# Abel Upgrade Modification Environmental Assessment

Response to Submissions

## RESPONSE TO SUBMISSIONS

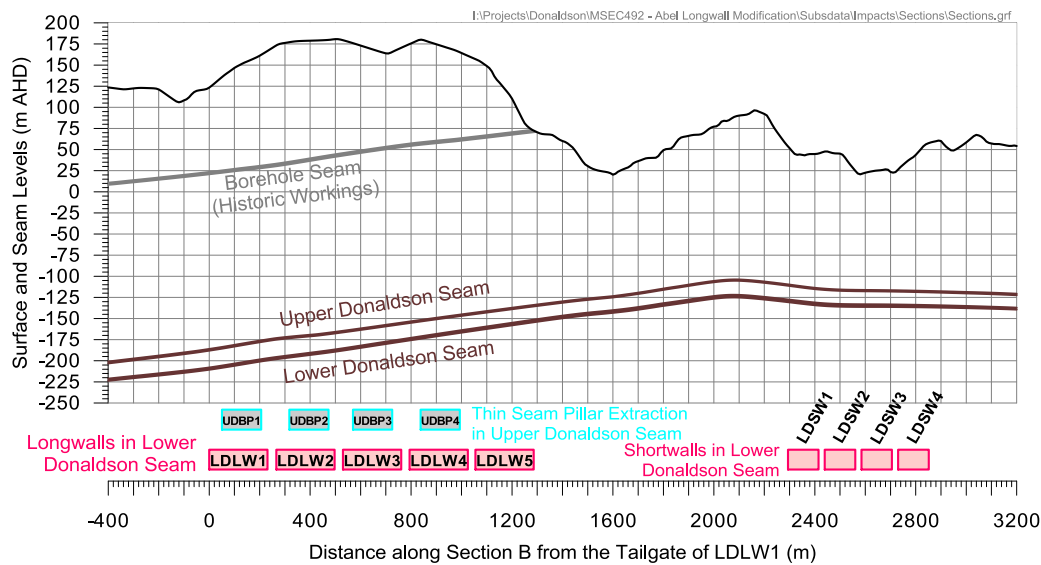
The northern ends of the proposed shortwalls in the Lower Donaldson Seam are also partially located beneath the historic workings in the Borehole Seam. The interburden thickness between the historic workings and the Lower Donaldson Seam is around 225 m in this location (see cross-section below).
